Comments to: 100 AVENUE ROAD (THEATRE SQUARE) DRAFT CMP
– CONSULTATION STATEMENT – 05/12/17. Ref: [2017/6638/CMP](#)

30/01/18

- Camden's Catchment Area for notification for Original Planning Application 2014/1627/P
- EL's Catchment Area for CMP they claim they notified [Appendix D2]

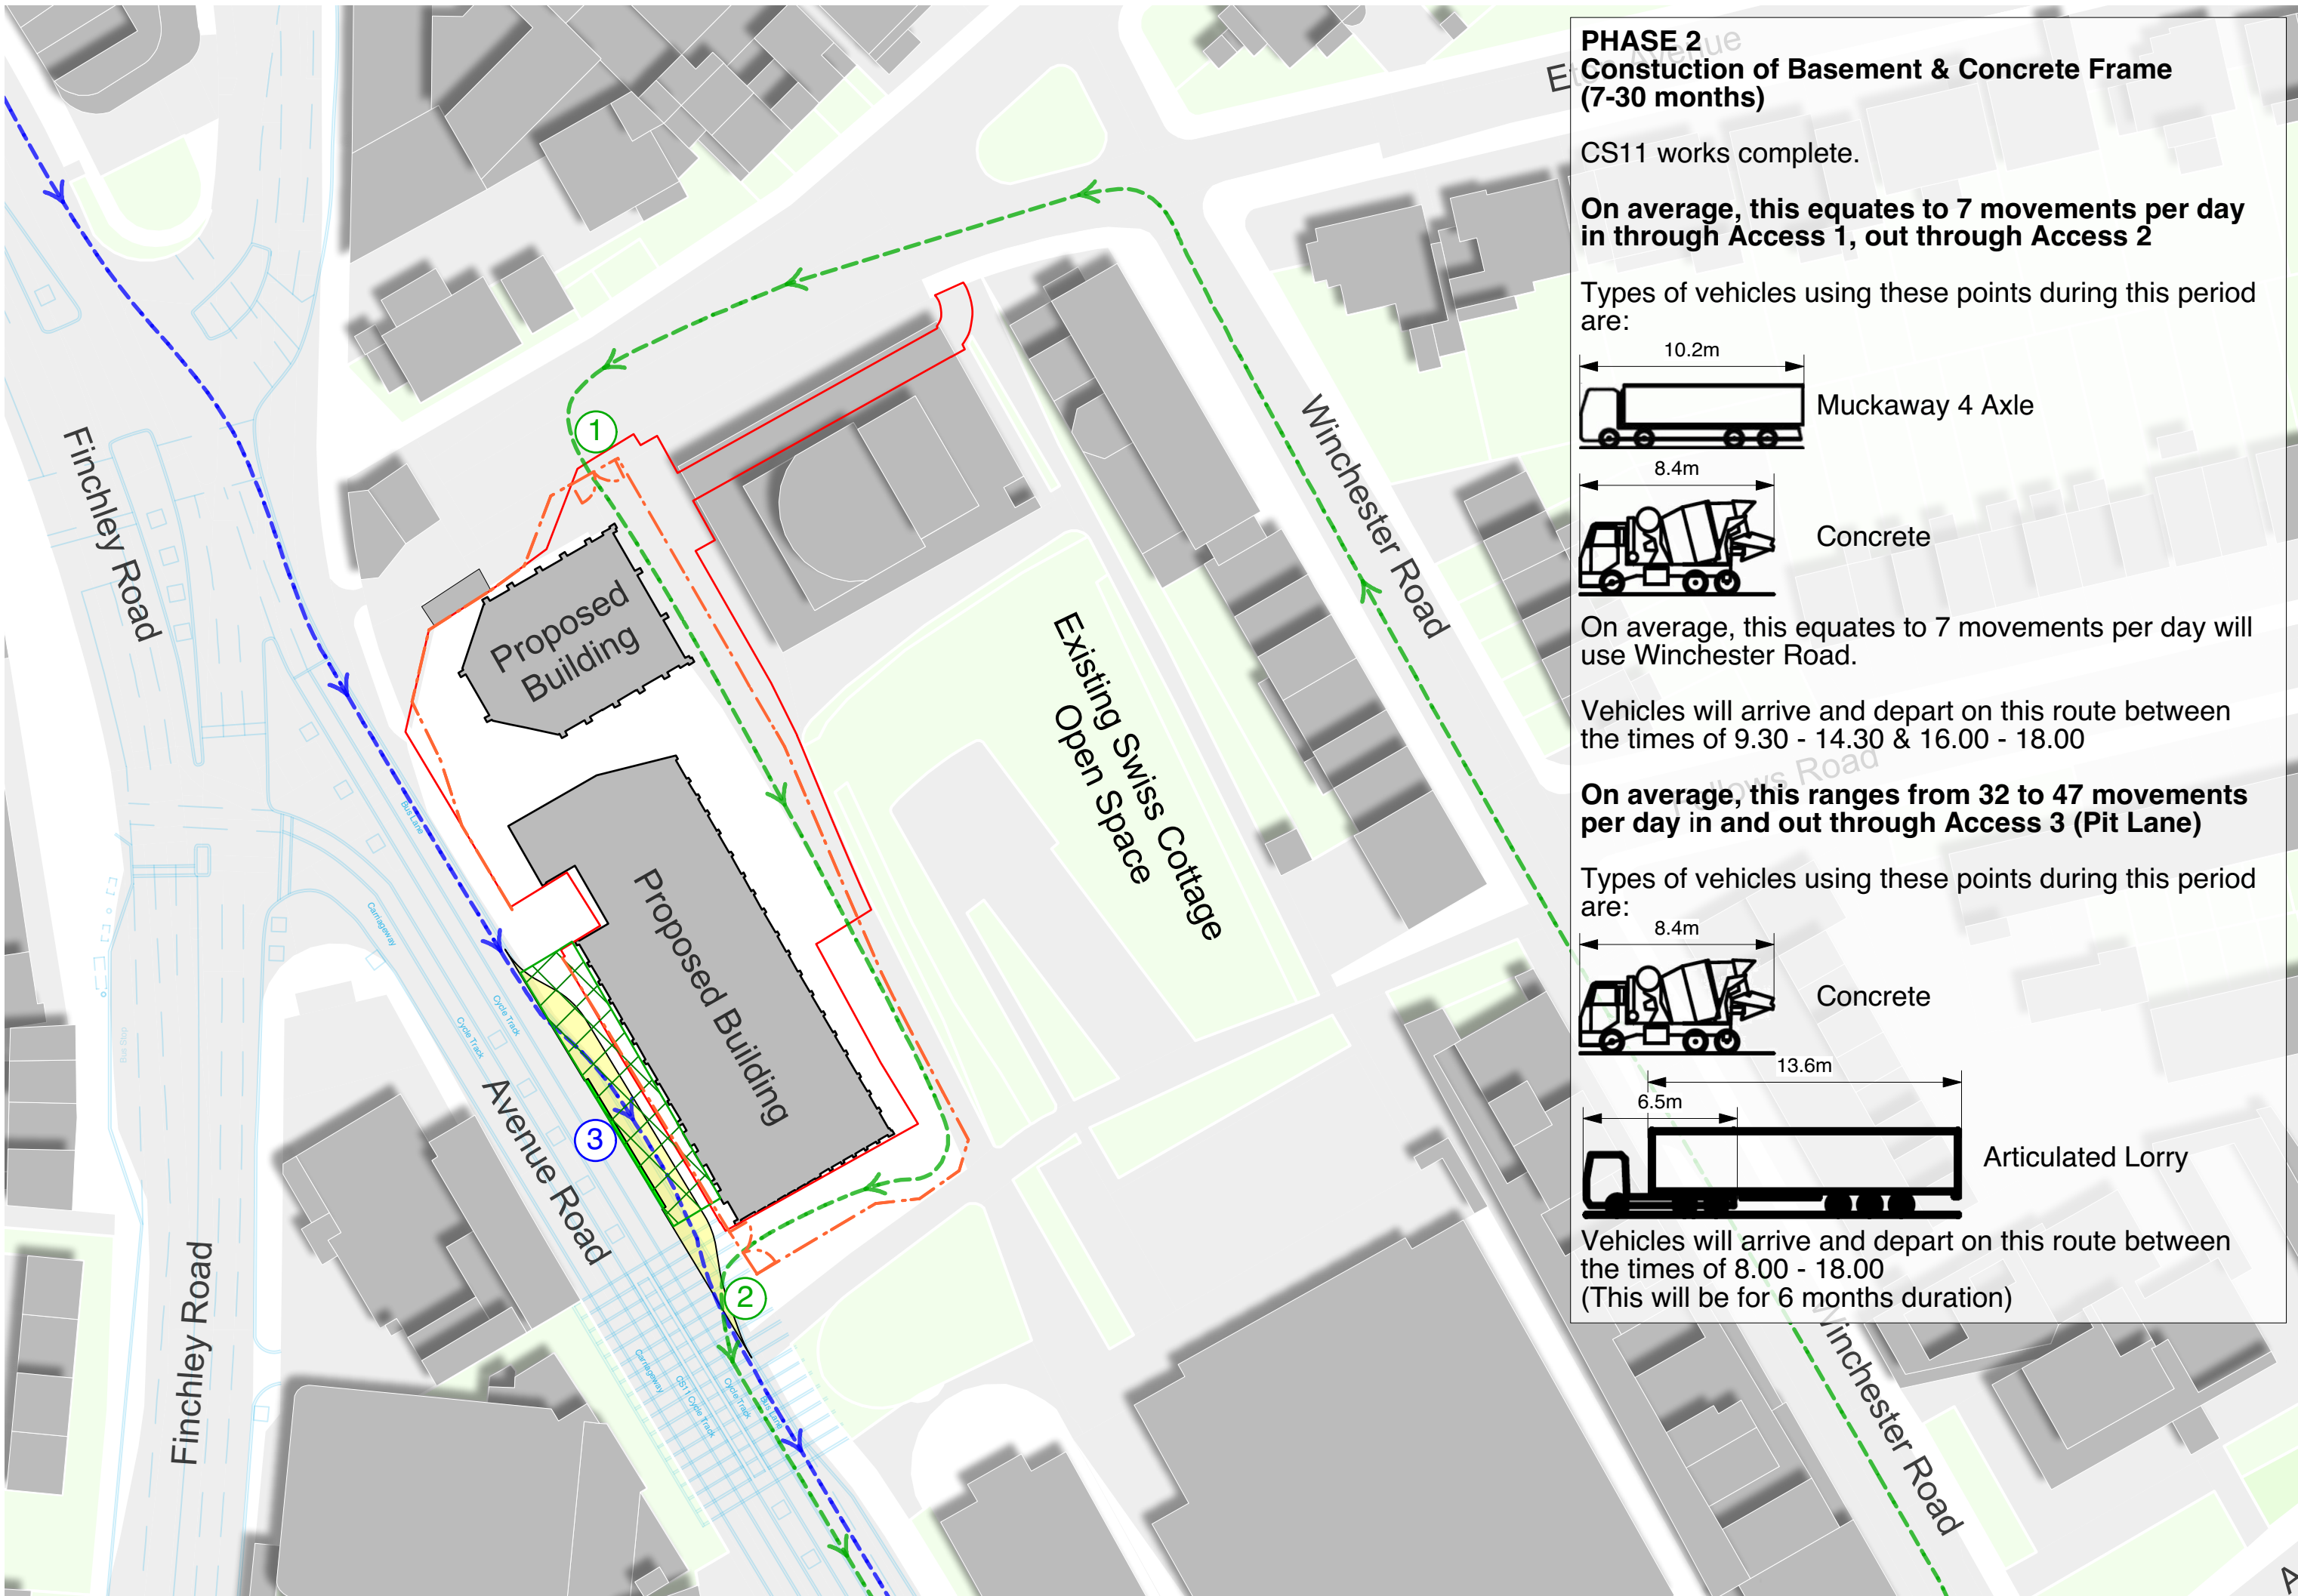
- 2.7. Yet Principle Planning Officer Jonathan McClue informs us in his email [19/12/17] that: *"it was suggested that EL consult as per the original planning application as a minimum. The (EL) map.... was not produced by the Council."* Please compare

Camden's catchment area with EL's, and a list of all the streets that were notified about the original application 2014/1617/P. Note that Camden's Catchment area is more than 3 times the size of EL's. [\[See Appendix 1\]](#)

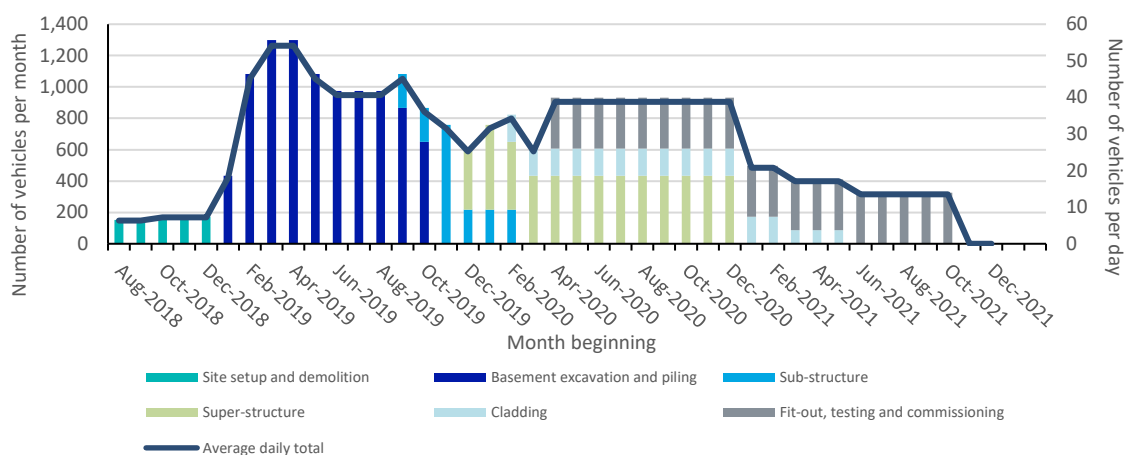
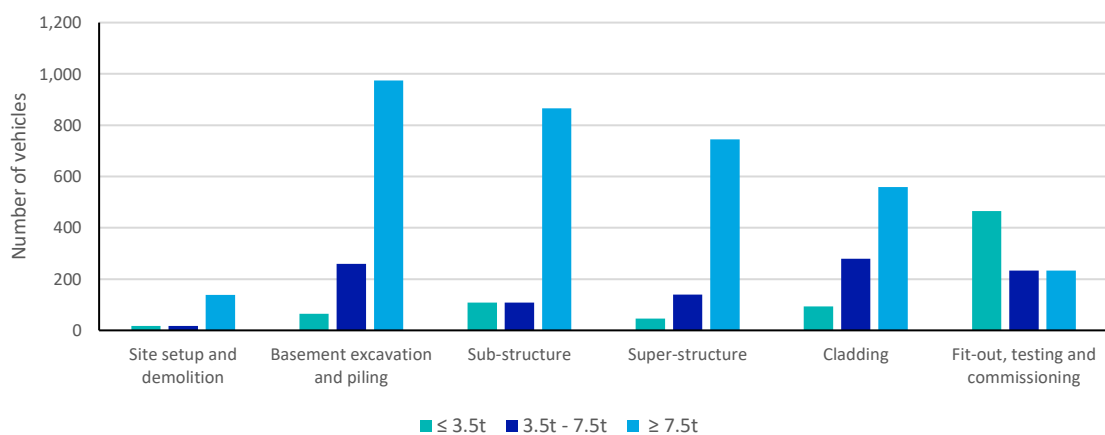
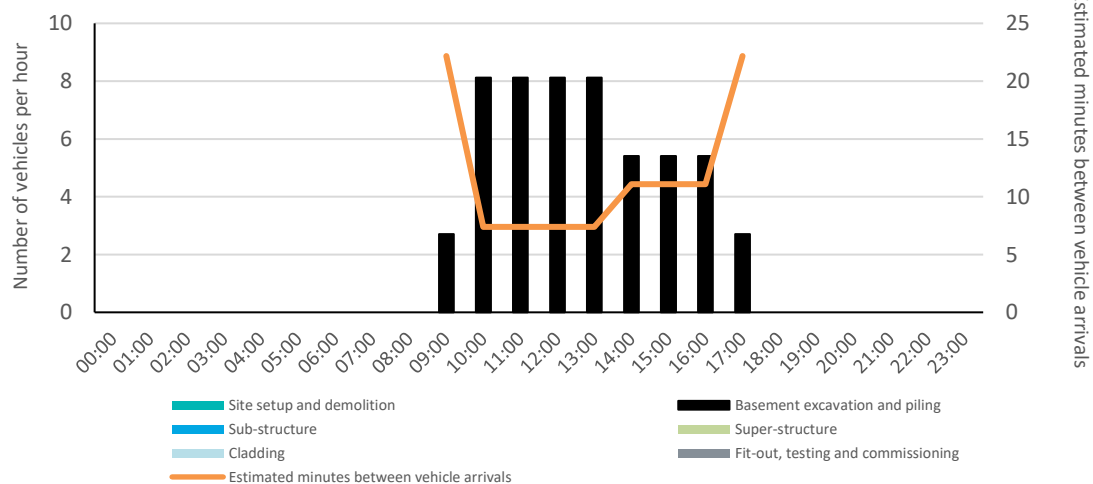
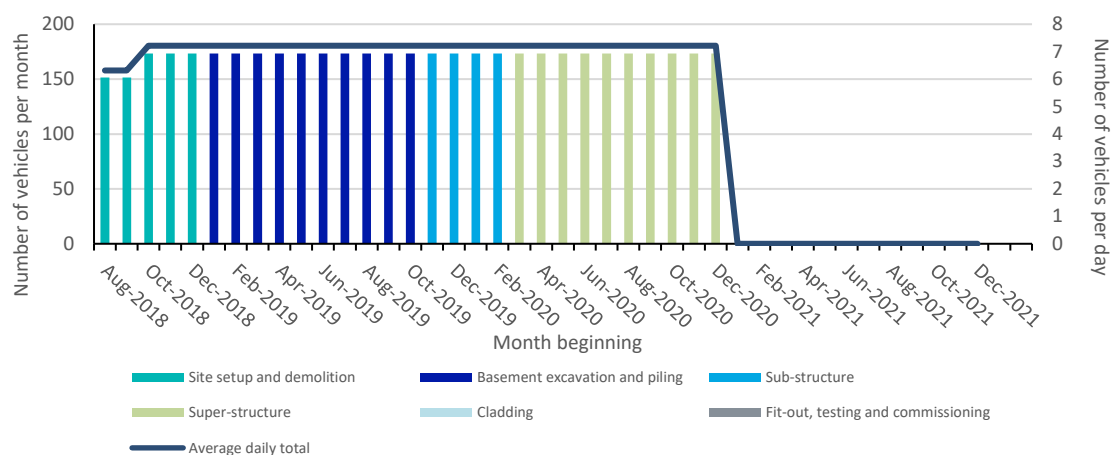
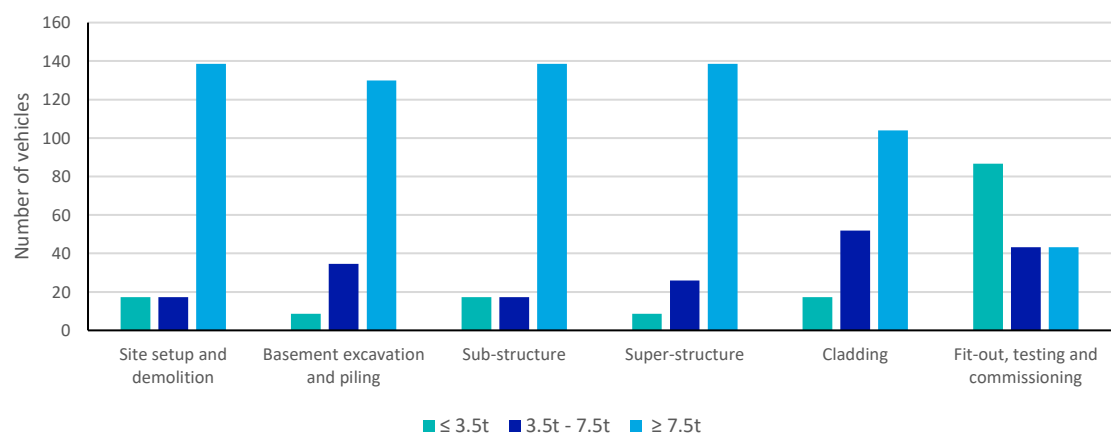
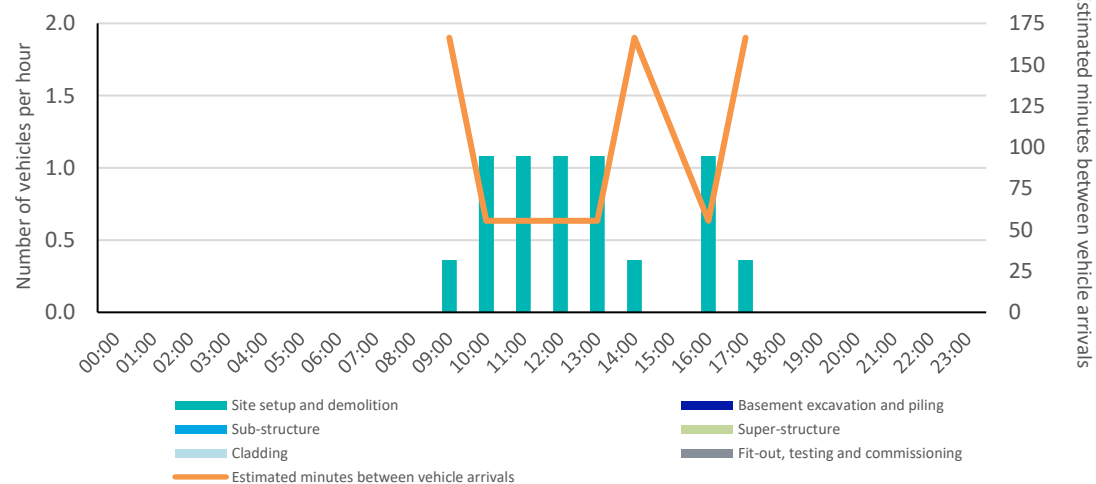
- 4.5. The latest figures in this ‘Submitted CMP’ also do not tally:

Compare daily totals in Appendix G with Appendix F

<u>Appendix G:</u>	Phase 1 = 7 per day	Phase 1b = 8 - 27 per day
<u>Appendix F:</u>	Phase 1 = 14 per day	Phase 1b = 57 per day.

Appendix G needs to be amended to reflect the 14 vehicles per day in Phase 1. The discrepancy of 30 extra vehicles per day for Phase 1b needs to be accounted for in both appendices. There may be other anomalies not spotted.

Also it is not clear in Appendix F, Phase 2, whether the maximum of 7 vehicles per day applies to just the Muckaway trucks or to both the Muckaway trucks and the concrete mixers. We need to know how many there will be of each.
